STAFF REPORT**COMMUNITY DEVELOPMENT DEPARTMENT**

HEARING DATE: 9/14/2021

SUBJECT: H-2021-0036
Briar Ridge Subdivision

B. Preliminary Plat (dated: ~~4/7/2021~~ 9/3/2021)

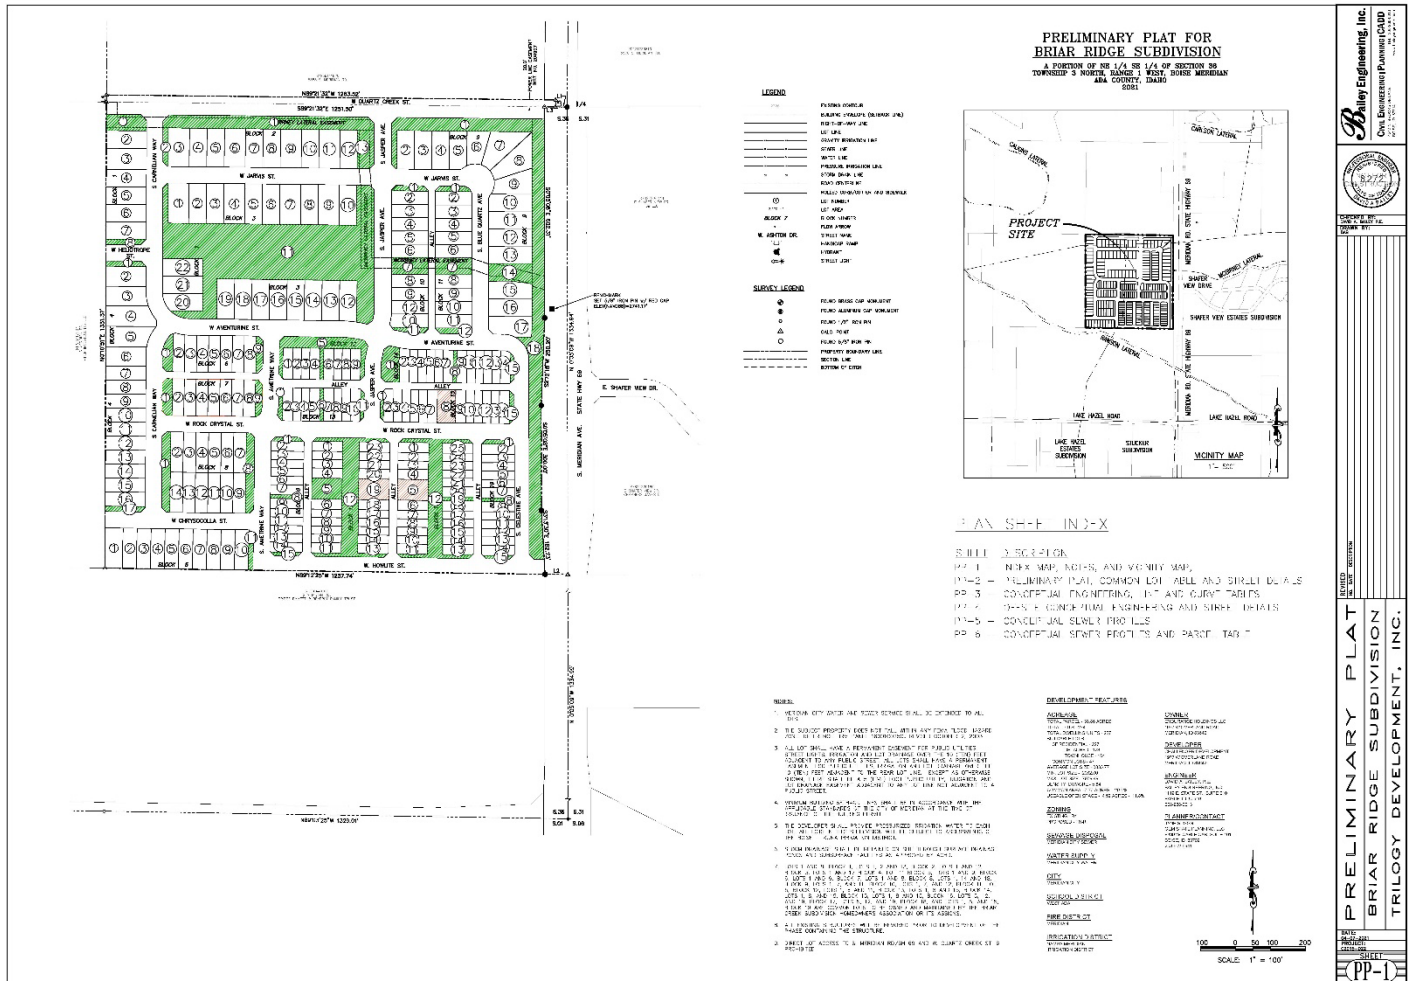
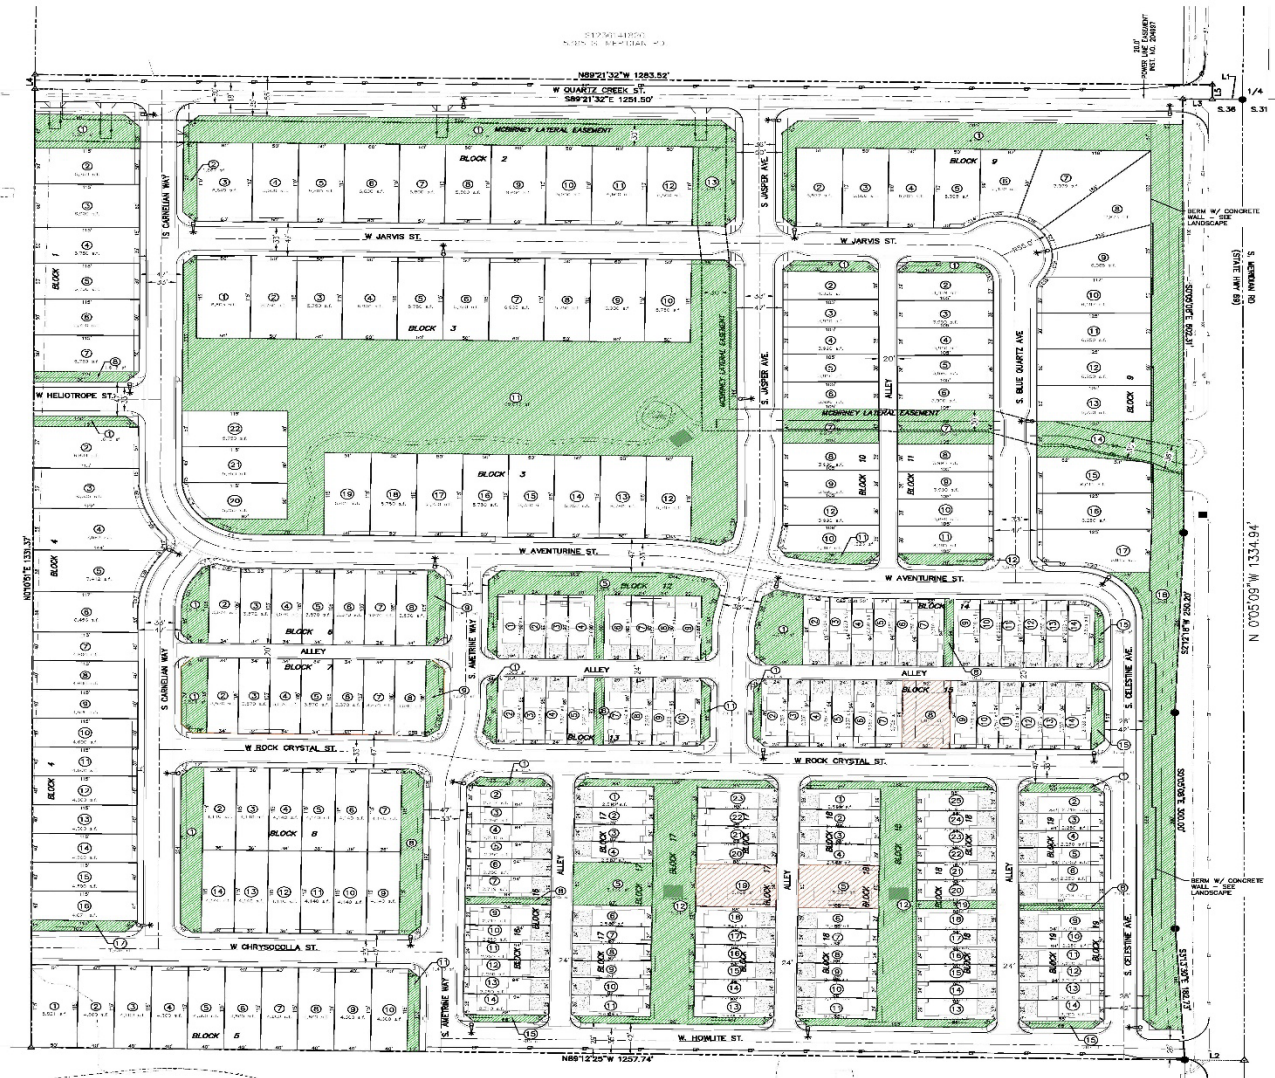
Note: The alleys shown on the plat for the attached units in the southeast quadrant of the project do not meet ACHD policies for an alley because the units front on green space instead of a public road. Therefore, this alley must instead be constructed as a “minor urban local street” which is a minimum of 24 feet wide with curb and gutter and no parking is allowed on either side. Staff is recommending a condition of approval in line with ACHD’s condition to ensure this street segment is revised and has coordinated with ACHD to not require sidewalks on these internal “alleys” because the project is proposed with detached sidewalk and parkways throughout the entire development. The Applicant should revise the width of these roads to meet ACHD policy—this may lead to a reduction in green space between these units.

*Overall, Staff supports the proposed open space but does have recommended revisions for the large open space lot (Lot 1, Block 3) in the north half of the development to make it more open and eliminate potential crime issues. **First, Staff recommends shifting the block of homes on the south end of this open space lot (Lots 18-25, Block 3) to the east to have more room on the west end of this block. Secondly, Staff recommends moving at least two lots from the west boundary of this open space lot (Lots 13-17, Block 3) to the south boundary to front on W. Aventurine St. and match the home placement on the north side of this open space lot.** This appears to require a loss of three (3) lots based on dimensions but the Applicant may be able to recover the lost lots by incorporating additional townhome units as previously discussed. If the Applicant can make these revisions without losing 3 lots, Staff would also support that as the Applicant is well within the allowable density for this site.*

2. The preliminary plat included in Section VII.B, dated ~~April 7, 2021~~ September 3, 2021, ~~shall be revised as follows prior to the City Council hearing:~~ is approved as submitted.

- a. ~~Revise the plat to reorient remove building lots (Lots 13-17, Block 3 and Lots 18-25, Block 3) on the west and south side of the large open space lot (Lot 1, Block 3) to open up this central open space lot for visibility and access mirror the layout on the north side of this lot to only have lots on the south side of the open space lot fronting on W. Aventurine Street, per the analysis in Section V.L.~~

- b. ~~Revise the proposed alleys between the townhome lots in Block 17 & Block 18 to be minor urban local streets constructed at a minimum of 24 feet wide with curb and gutter, no sidewalks, and no parking on either side, per ACHD requirements.~~

- c. ~~Add striping or other traffic calming measures (i.e. bulb outs) where the proposed multi-use pathway crosses local streets within the development; coordinate with Meridian Fire and ACHD as necessary.~~

- d. ~~Add a plat note stating that direct lot access to S. Meridian Road/SH 69 and W. Quartz Creek Street is prohibited.~~
3. The landscape plan included in Section VII.C, dated March 10, 2021, shall be revised as follows prior to ~~the City Council hearing~~ Final Plat submittal:

C. Landscape Plans (date: 3/10/2021)

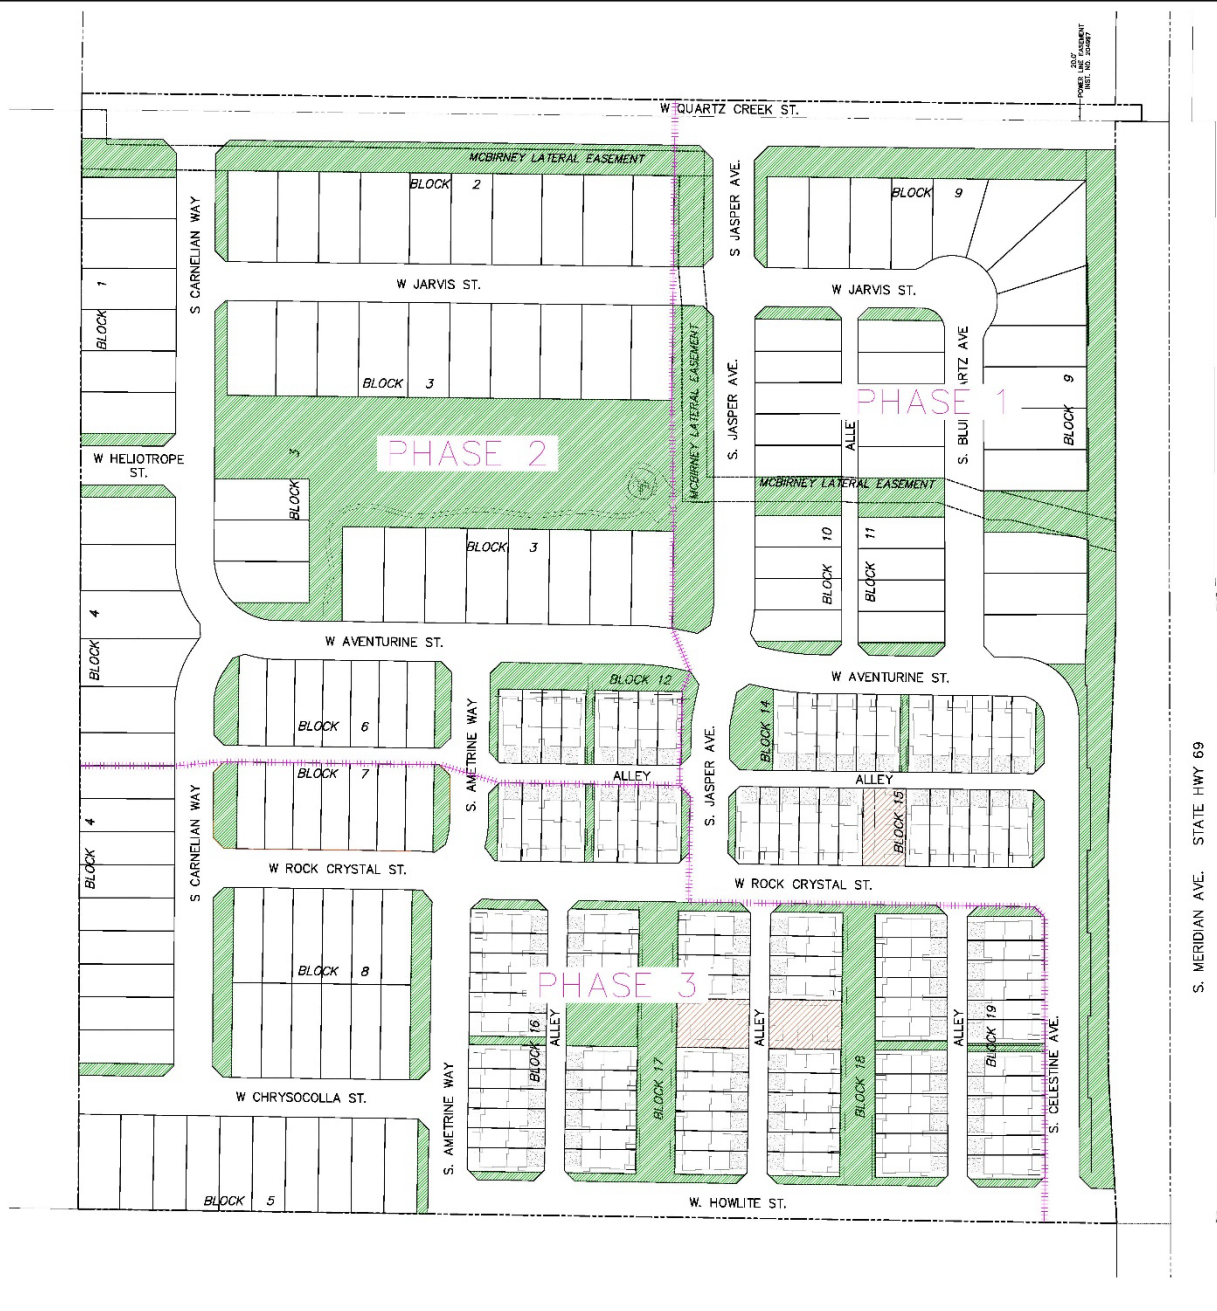
All fencing is required to comply with the standards listed in UDC 11-3A-7. Fencing is proposed as shown on the landscape plan and appears to meet UDC standards as proposed except for the 6-foot closed vision fencing proposed adjacent to the large open space lot (Lot 1, Block 3) in the north half of the site and shown on the rear lot line of the homes surrounding this open space lot.

Per UDC 11-3A-7A.7b, when an open space lot is greater than 250 feet in length, an open vision or semiprivate fence shall be used. The closed vision fencing shown on the landscape plans does

not comply with this code section. The Applicant should revise the landscape plan at the time of the applicable final plat application. Staff's recommendation to make this open space lot more linear in nature does not remove the need for this fencing revision because the lot is deeper than 250 feet.

- a. Revise the landscape plan to match the revised plat ~~revisions noted in VIII.A2 above.~~
 - b. Show striping or other traffic calming measures (i.e. bulb-outs) where the proposed multi-use pathway crosses local streets within the development; coordinate with Meridian Fire and ACHD as necessary.

- c. Prior to Final Plat submittal, add two (2) new lines of calculations in the landscape calculations table to show the linear feet of parkways and linear feet of pathways and include the required number of trees and proposed number of trees in accord with UDC 11-3B-7C.
